**APPENDIX 4B**

**DETAILED DRAWINGS FOR THE 200 AREA EFFLUENT TREATMENT FACILITY  
CONTAINER STORAGE AREA AND TANK SYSTEMS**

1. ECN 647892

ENGINEERING CHANGE NOTICE  
CONTINUATION SHEETDOCUMENT NO.  
H-2-89183DATE  
8/10/99

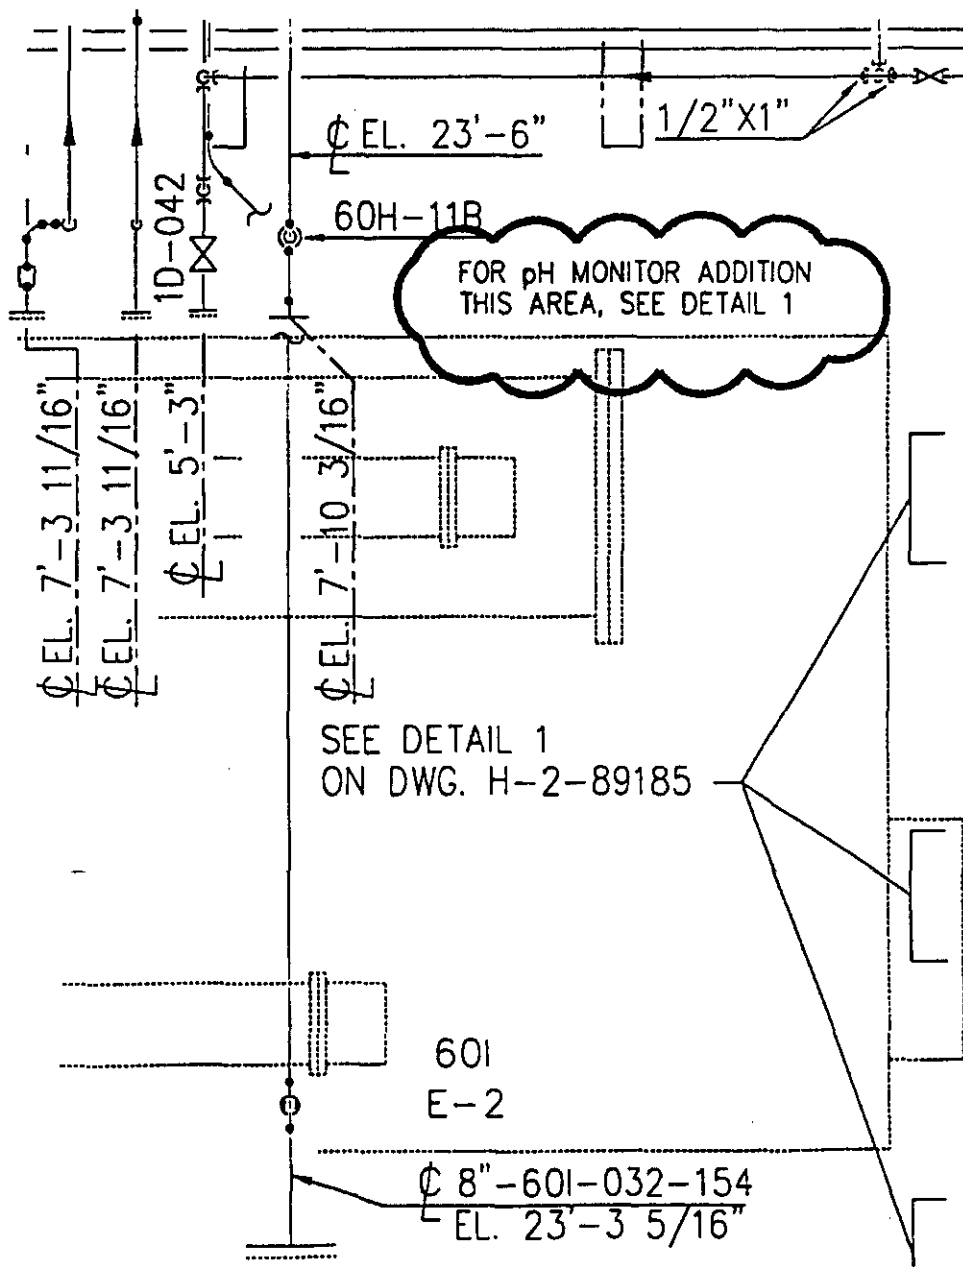
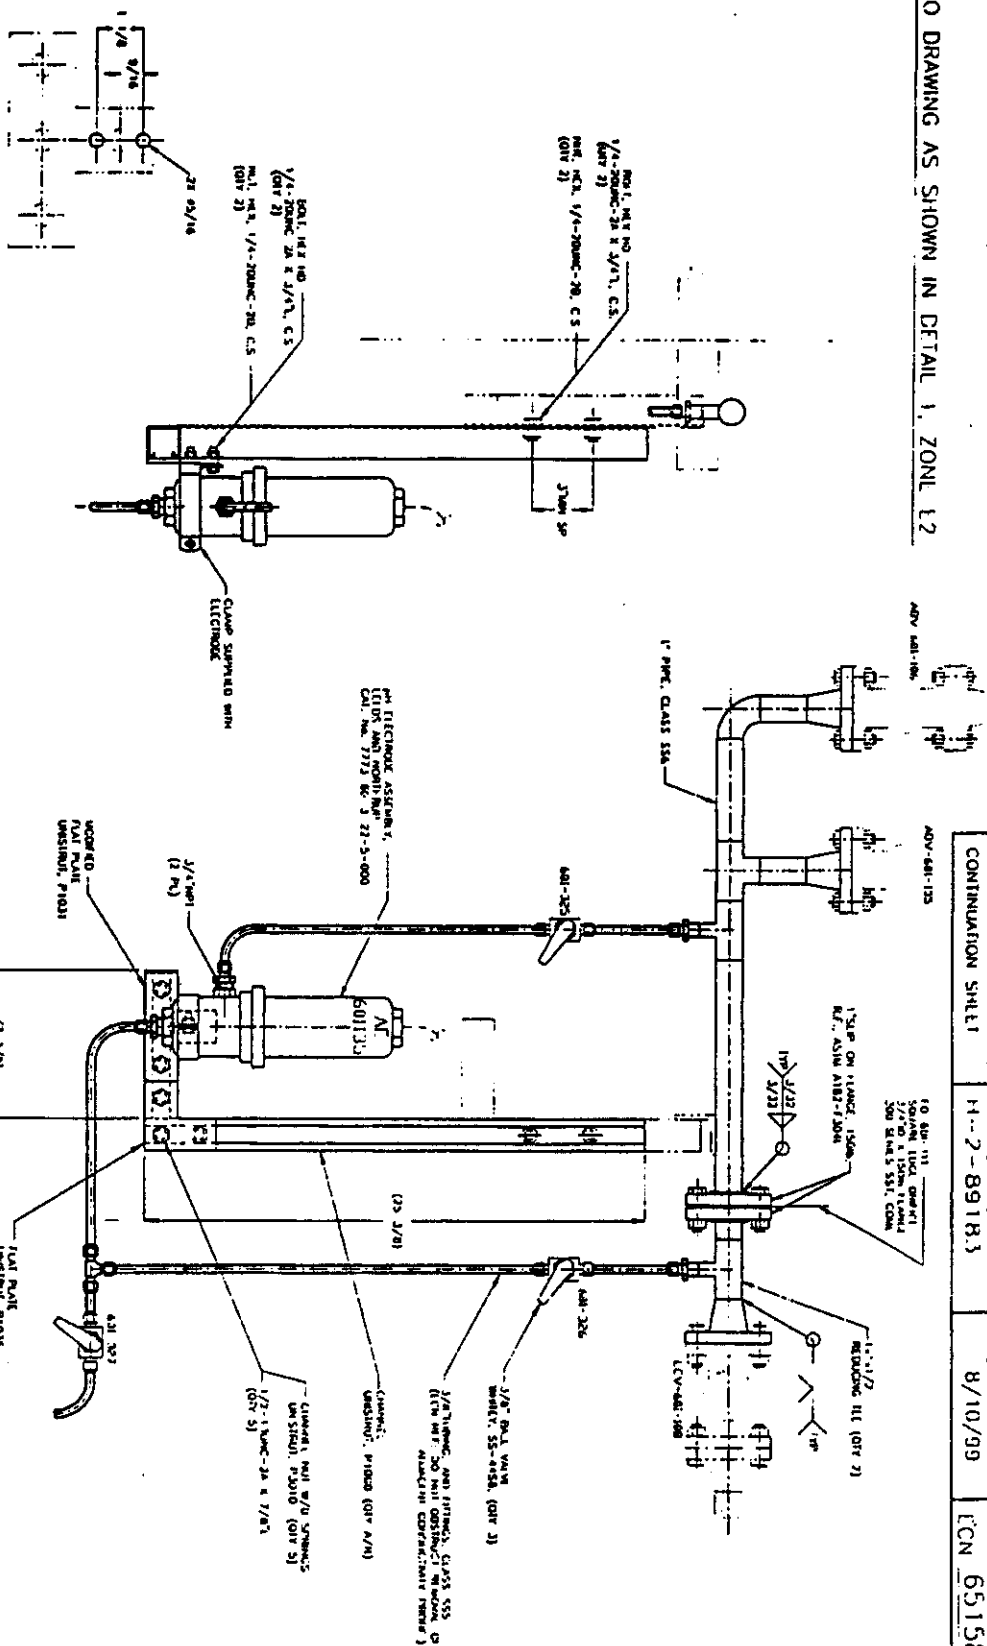
REVISE AS SHOWN BELOW IN CLOUDED AREA. (ZN E6)

ADD TO DRAWING AS SHOWN IN DETAIL 1, ZONE E2

H-2-817974, Sheet 1, Rev. 2, Zone C-7 to D-7

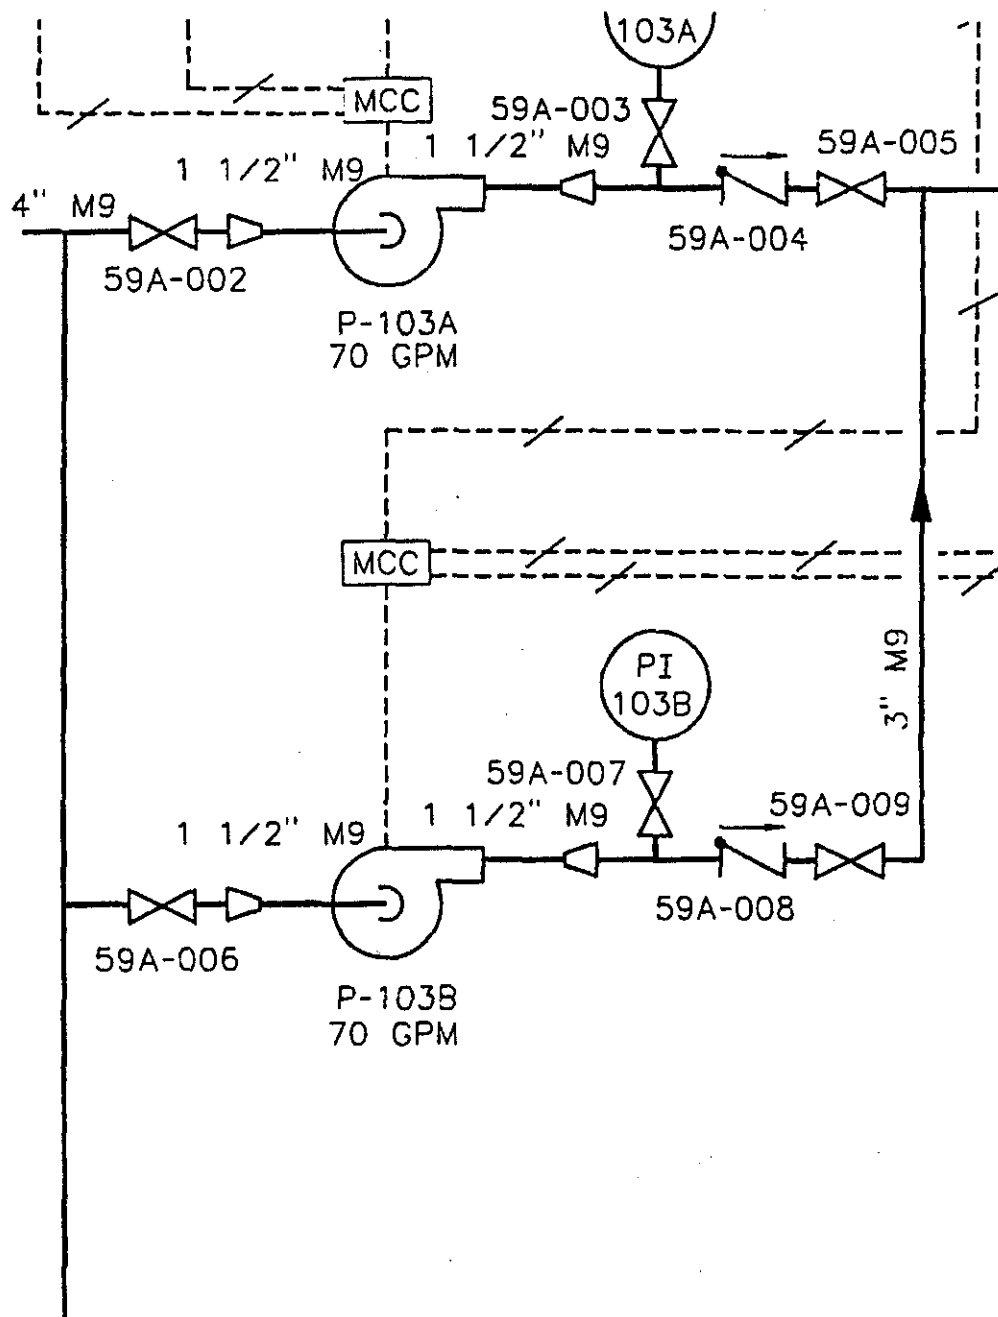
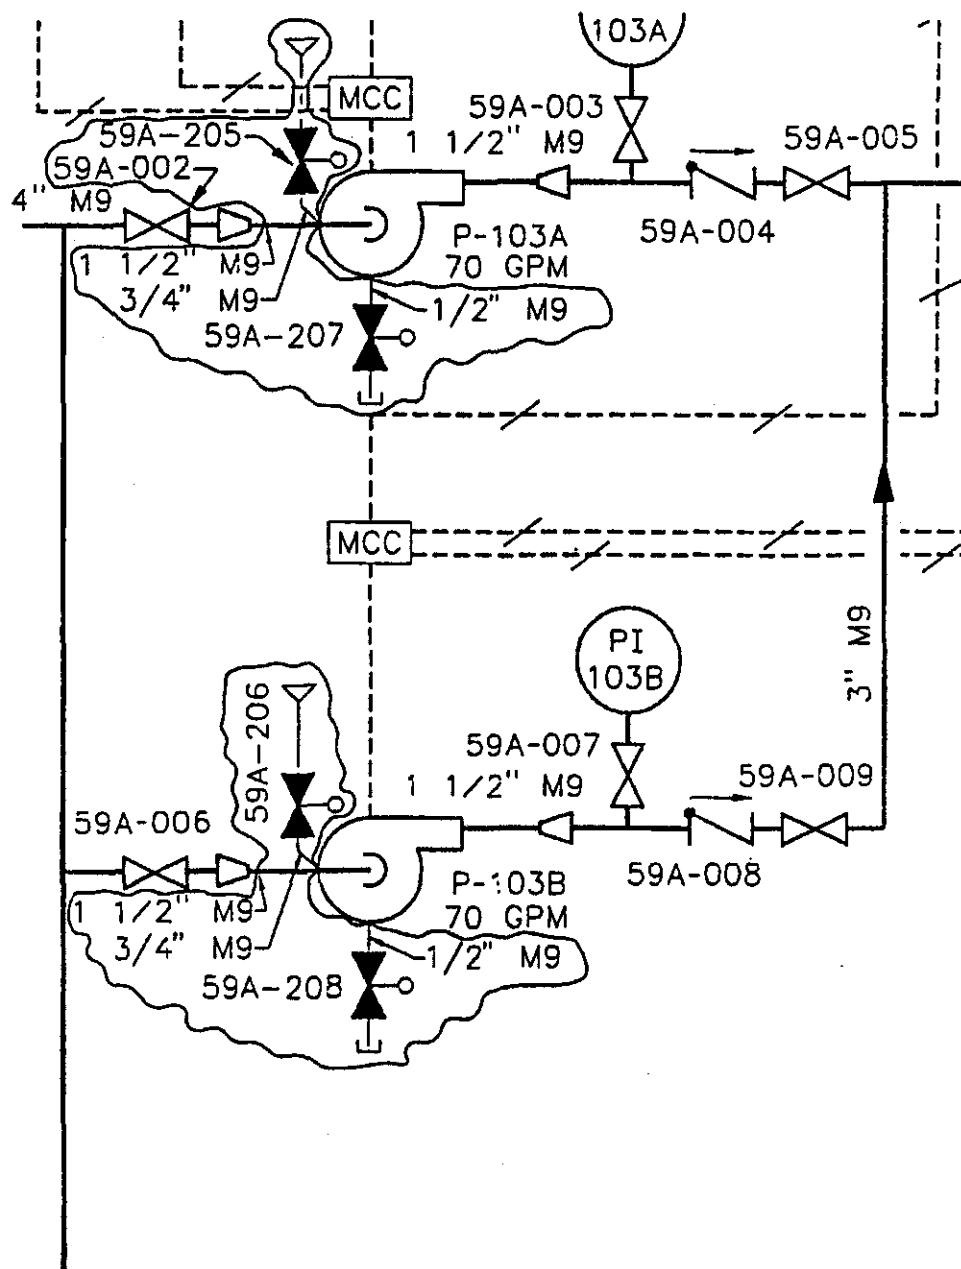
IS:

CHANGE TO:
